DESIGN REVIEW - RECOMMENDATION PROPOSAL

300 W Republican Street, Seattle, WA 98119

NEW MULTIFAMILY BUILDING | KOZ DEVELOPMENT

SDCI # 3036974-EG
West Design Review Board Meeting Packet
for August 18, 2021

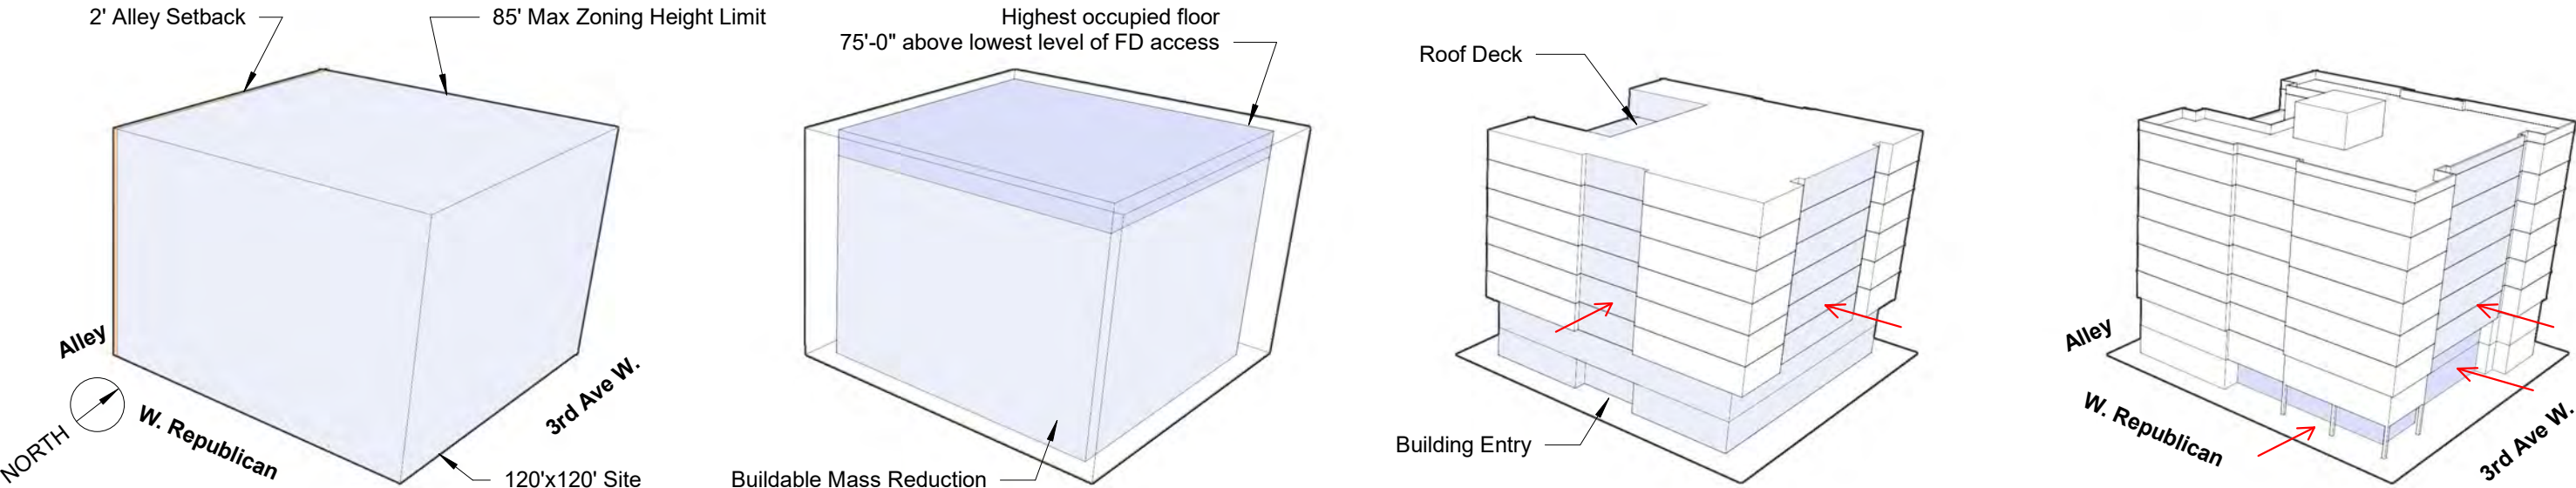
a.) The Board was concerned that the proposal lacked a strong design concept and was divided in their support for Option B and Option C. The Board majority ultimately supported Option C – the applicant’s preferred massing option – for further development in response guidance and priority Design Guidelines. (DC2)

Response
Facade massing articulation is a direct function of the interior program and external site constraints. The form follows the function.

① Corner Layout Design Revision Study Option II
3/32" = 1'-0"

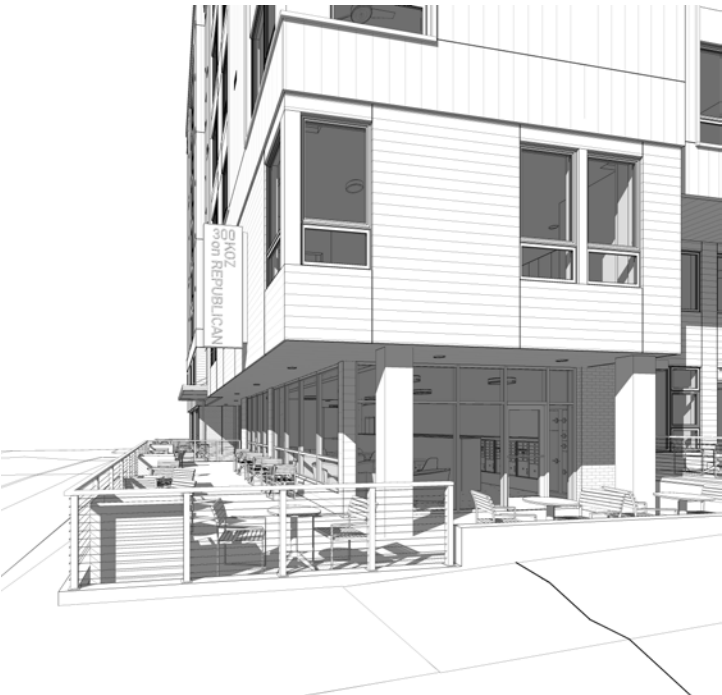
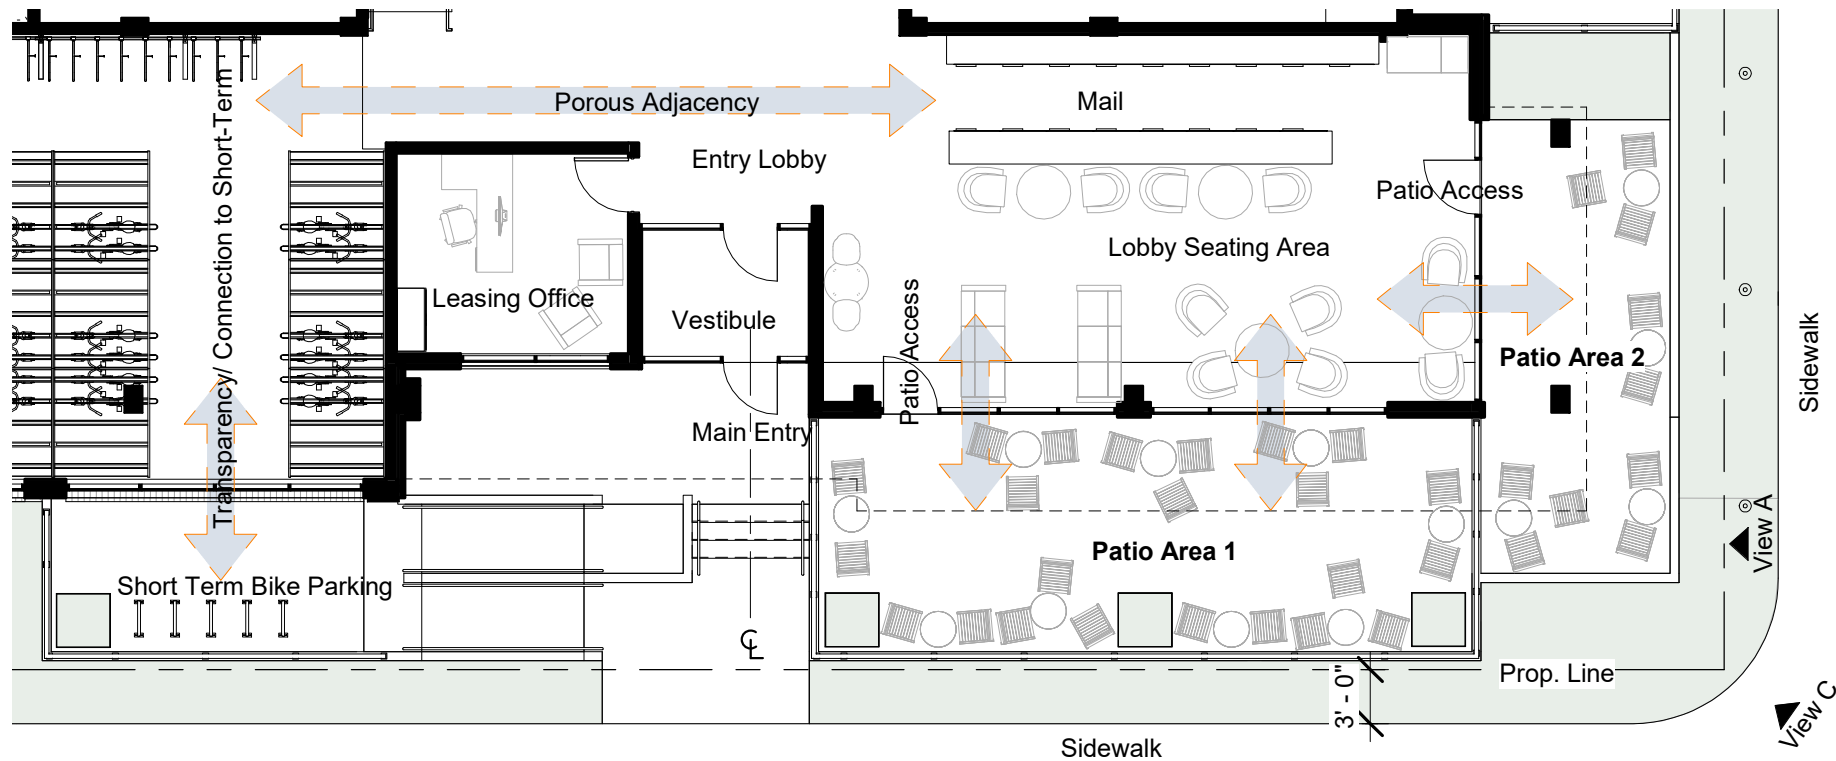
f.) In response to public comment, the Board specifically prioritized Uptown Design Guidelines **CS2-1**, Sense of Place; **CS3-1**, Placemaking; and **DC2-1-a**, Arts and Cultural District. (CS2-1, CS3-1, DC2-1-a)

Further develop the corner exterior amenity space.
The other design options created “barriers” between the public way and the building amenity spaces (lobby and patio). Columns are large, fence is used at the SW concrete wall, and the planters have large concrete walls which block views. The next design progression was to explore ways to better activate the corner patio space, increase the visual connection and transparency from the sidewalk.

The provided study explores a new configuration of the corner patio. The concrete planters and picket fence have been removed and the wall of the interior lobby has been moved out several feet towards the sidewalk. The exterior patio has also been extended out closer to the property line and a cable railing is proposed to increase transparency and visual connection to the ROW. The large columns have been reconfigured and have been hidden or blend with the new arrangement. The east portion of the patio has been redesigned such that the main access point onto the patio is located along the east façade from the lobby and the storefront glazing along this façade has been taken all the way to the ground for a greater sense of transparency. This study resulted in a positive change and is now considered the preferred option.

1 EAST - Partial Elevation Stepped Option II - Current Design
3/16" = 1'-0"

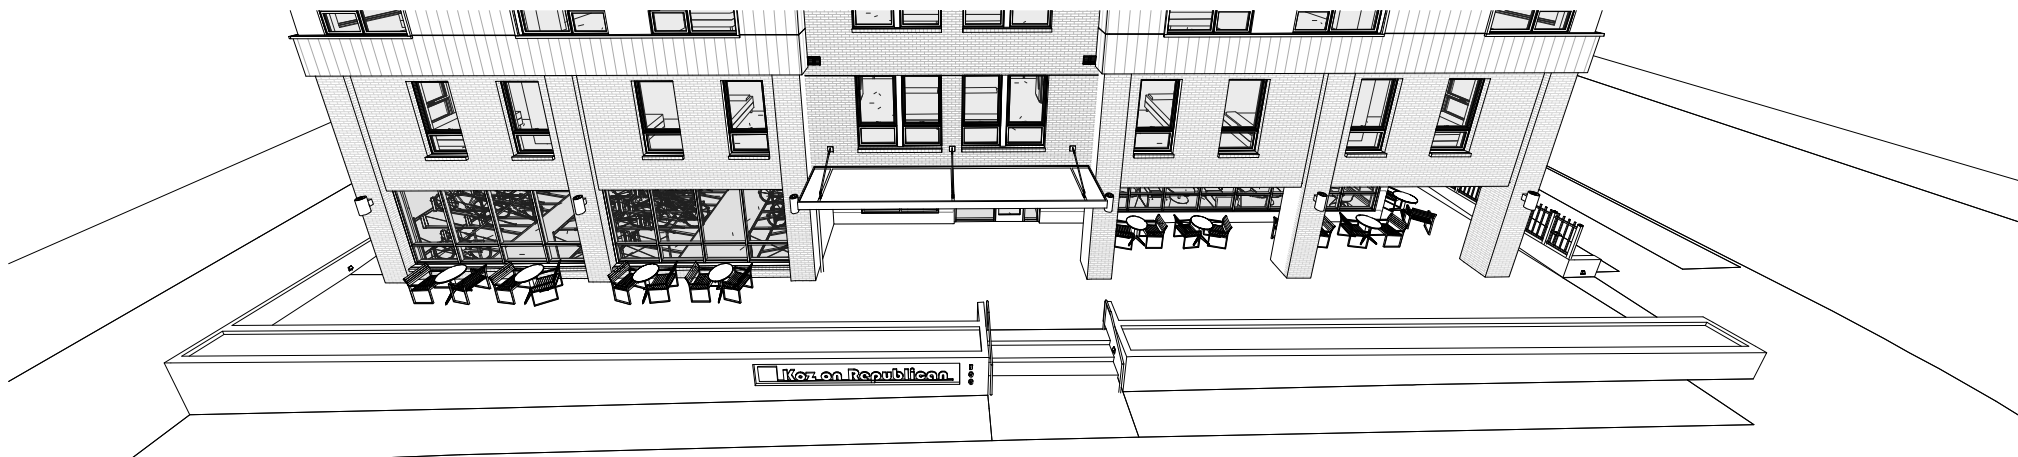
a.) The Board was divided in their support of the two alternative approaches to access to ground-level units (Options A/C versus Option B) and encouraged further study of the entry experience along 3rd Ave W. The Board heard public comment and stated that the final design should be supported by these studies; informed by the rigorous façade composition; as well as contribute to privacy for ground level units, functionality, and a comfortable pedestrian experience. The Board specifically prioritized Uptown Design Guideline PL3-3, Ground Level Residential Edges. (PL3-A, PL3-B, PL3-3)

The ground level façade of the lower 2-story units along 3rd Avenue is stepped back from the 3rd level façade above approximately 4'-0" to increase courtyard space, increase façade modulation at the pedestrian level, and help with privacy for the lower level units. There is a material change at the lower level recessed portion of the façade to accent the 2-level private units and enrich the overall façade composition. Canopies are proposed over each of the exterior entries for weather protection (PL-3-a) and exterior lighting is provided at each door. A landscape buffer is proposed along the sidewalk between the public way and the private courtyards, and a low concrete wall and metal picket fence is proposed adjacent to the courtyard. The concept of this arrangement is to have a private, safe, and secure courtyard that is also visually connected to the public way.

The preferred option is a stepped approach which creates individual patios for the ground level residential units. To decrease the appearance of barriers all the concrete walls around the courtyards have been reduced to be as low as possible. The metal picket fence previously proposed has been changed to a cable railing to increase visibility and to compliment the rail used along the south façade. The overall height of the rail has been lowered to 3' and a gate is used to provide residents a sense of privacy and security without creating an imposing barrier.

② North Private Unit Courtyard
1/4" = 1'-0"

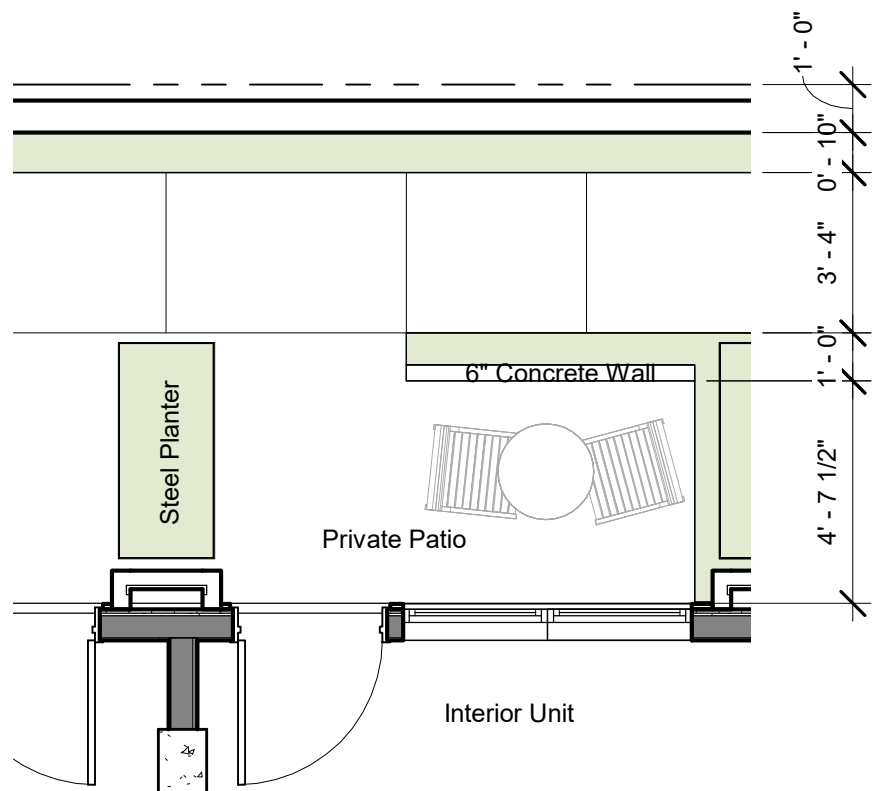
c.) The Board directed further study of the entry experience and design of the private patios along the north property line in response to Uptown Design Guideline PL3-3, Ground Level Residential Edges, and requested more detail on the design of these individual ground-level units in the Recommendation packet. (PL3-A, PL3-B, PL3-3)

The north building façade abuts an adjacent parcel, which will likely be developed in the future. To achieve large windows for the north facing units the façade was set back from the property line a minimum of 10' to take advantage of the 45% allowable unprotected openings and to provide "breathing" room from the adjacent parcel. This setback allows the units at level 1 to take advantage of the ground area for private courtyard space and will have direct access to the exterior from the units. Due to height constraints and interior program the level 1 units and courtyards are proposed to be set below grade at the level 1 elevation of 89.5, which is 7.11' below grade at the northeast corner, and 5.65' below grade at the northwest corner. The north courtyard layout was studied in two different ways; the first methodology was to use a higher pathway +/-30" above level 1 which lessens the severity of the height transition by providing a "stepped" approach to the grade transition but this greatly impacts the usable area of the courtyard spaces and crowds the circulation. The transition methodology is not the preferred approach. The second methodology approach to the layout looked at a single stair access up to the sidewalk level at the northeast corner. The full courtyard methodology maximizes the courtyard spaces, which also allows for more planting area and a greater feel of openness in the courtyard area. The full courtyard option will require a thoughtful treatment of the shoring wall along the north property line. The current design intent of the shoring wall will be to use textured concrete and climbing vines to soften the look and feel.

① Bike Room Layout
1/8" = 1'-0"

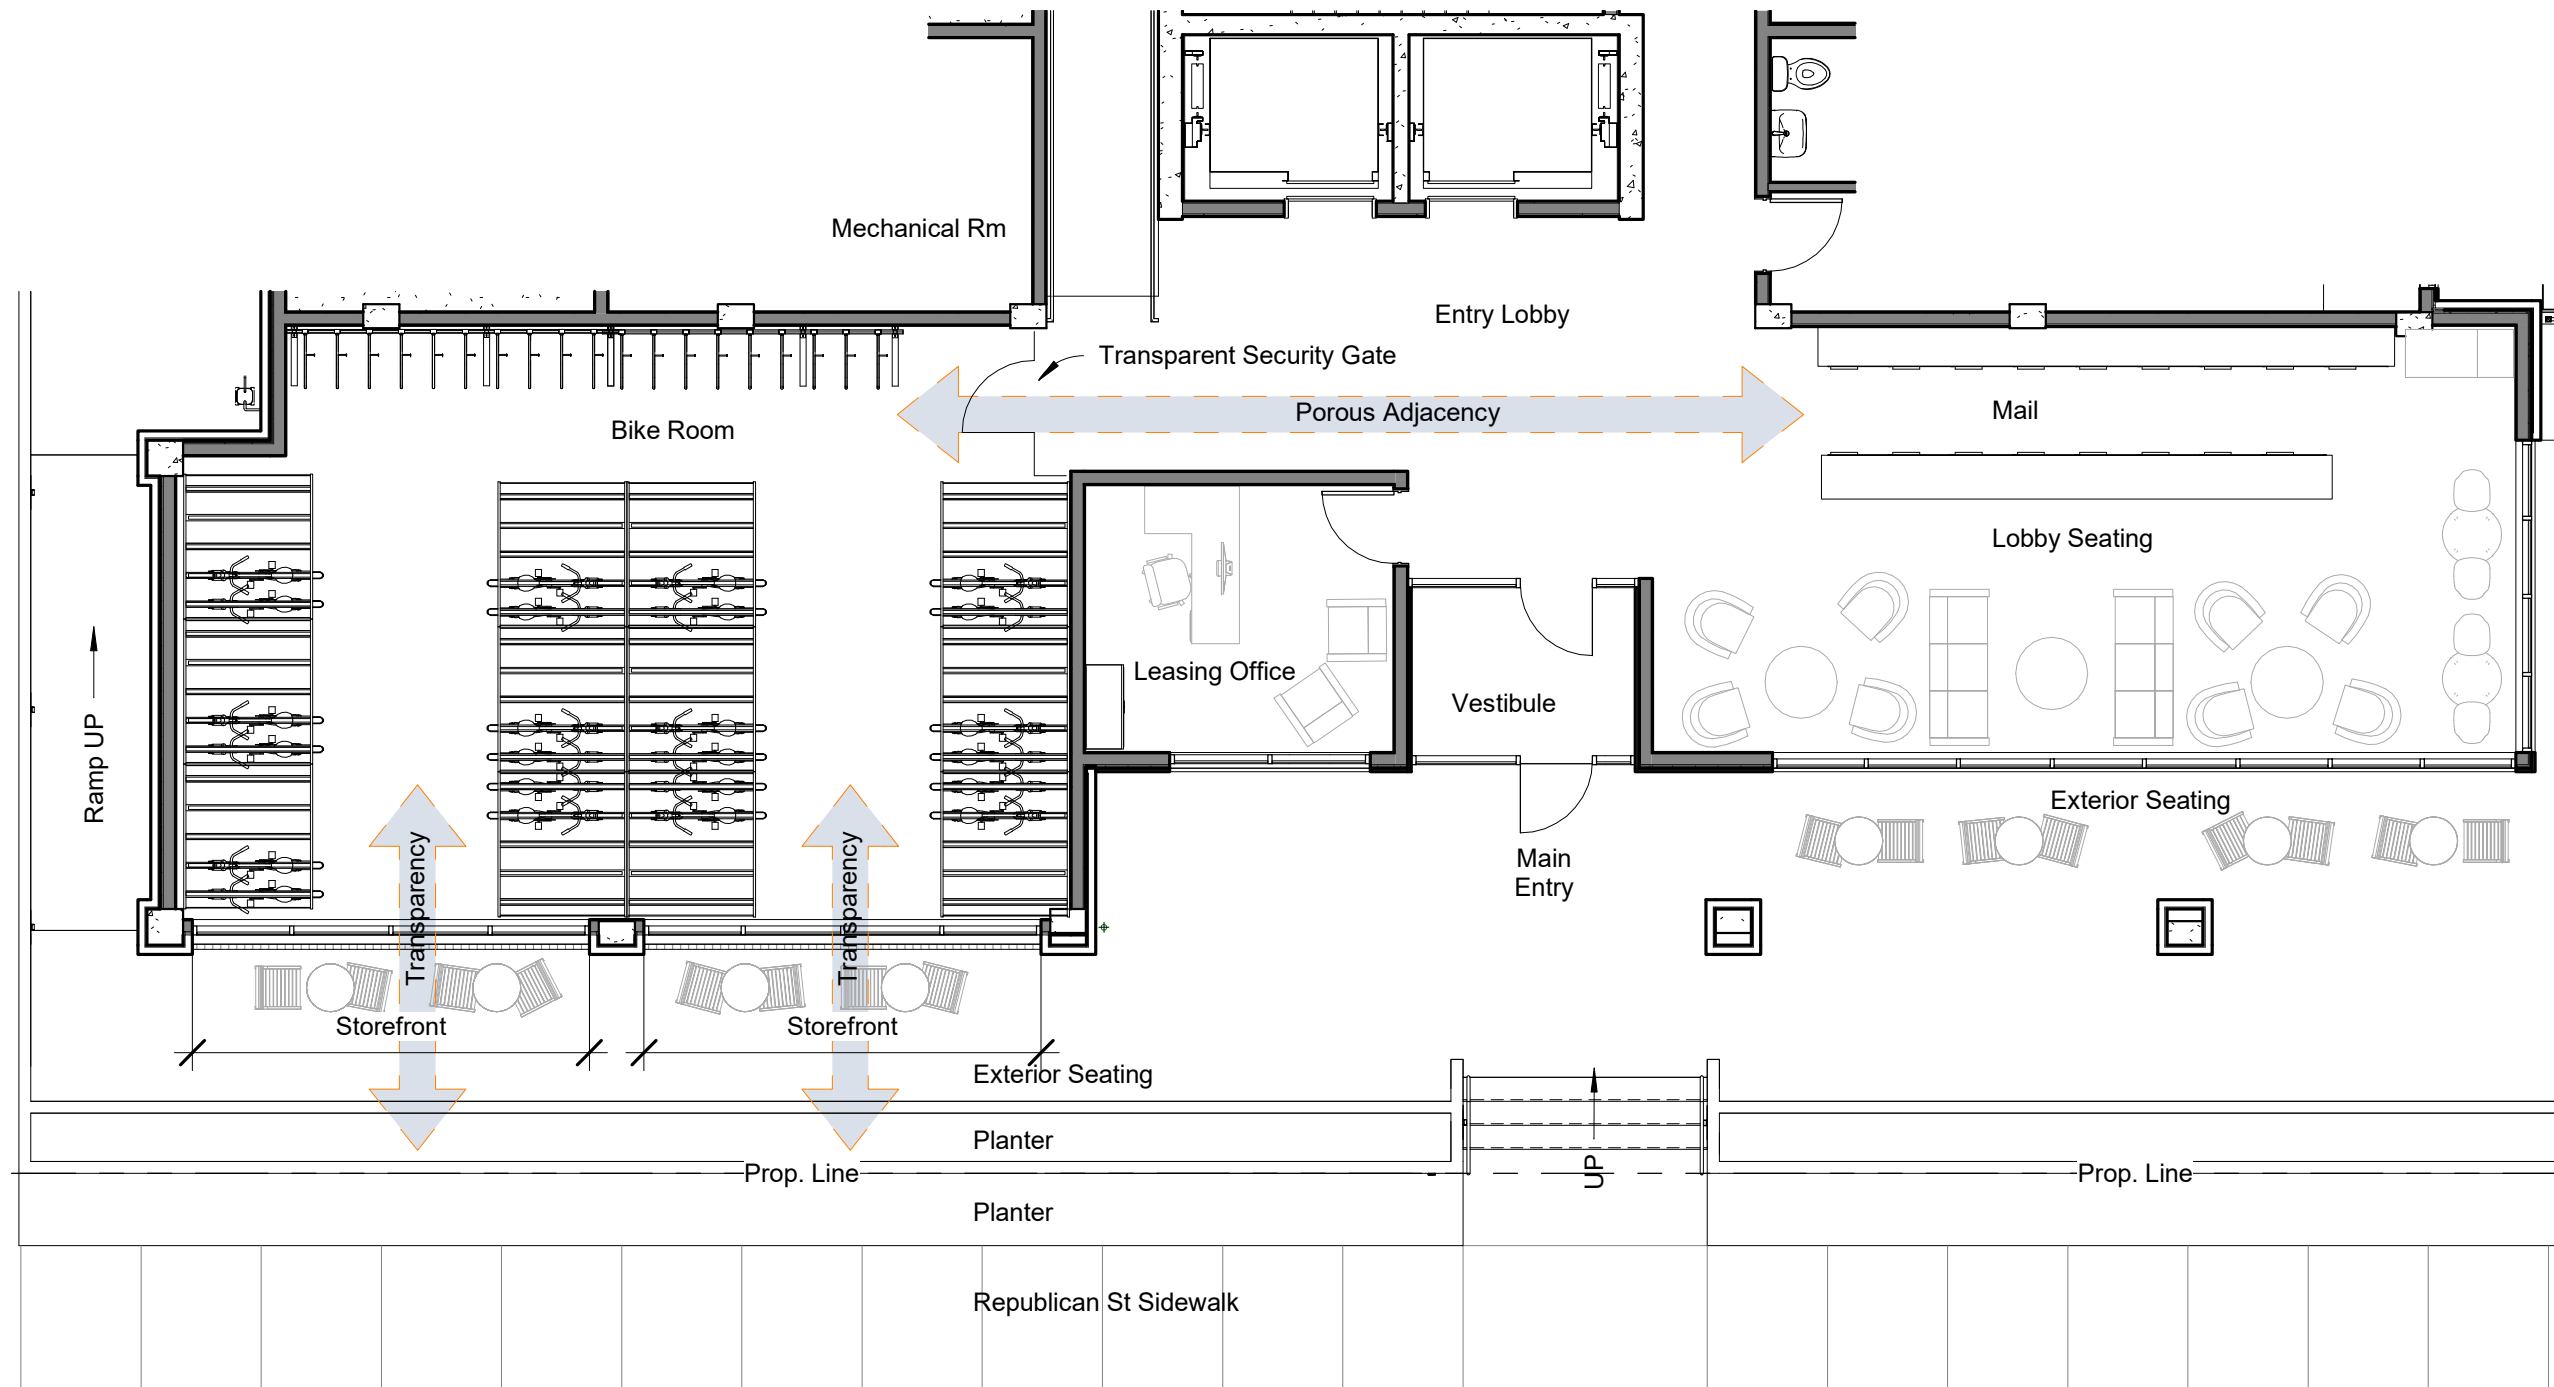
d.) The Board stated the bike storage room should be designed to be porous and transparent to engage the lobby and public realm. The Board specifically prioritized Uptown Design Guideline PL4-2, Planning Ahead for Bicyclists, and requested more information on the design of the bike storage room in the Recommendation packet. (PL4-2)

The main level primary entry is prominently located to be obvious, identifiable, and distinctive with clear lines of sight to the public right-of-way. The bike room and interior lobby seating area bookend either side of the building entry to create a porous interconnected space between the bike room, entry, and lobby areas. Generous glazing is used along the south façade to promote a storefront/retail like feel and also to increase the visual connection between interior and exterior. The choice of showcasing the bike room at such a prominent location punctuates the hierarchy of the function, supports the message that the bike room is not an “afterthought, and promotes the area’s goals of pedestrian activity and the message of using efficient transportation methods. Along with the location significance, security of the bike room is an important factor of the design; placing the bike room in a highly visible location adjacent to high traffic building functions increases security. A transparent security gate at the entry of the bike room will add additional protection for the bike storage and will support a visual connection to the overall lobby space. Lastly, the look and feel of the room will be designed as a playful space with graphics and bright color to further support the idea that the bike room is part of the overall space and is intentional vs an “afterthought”.
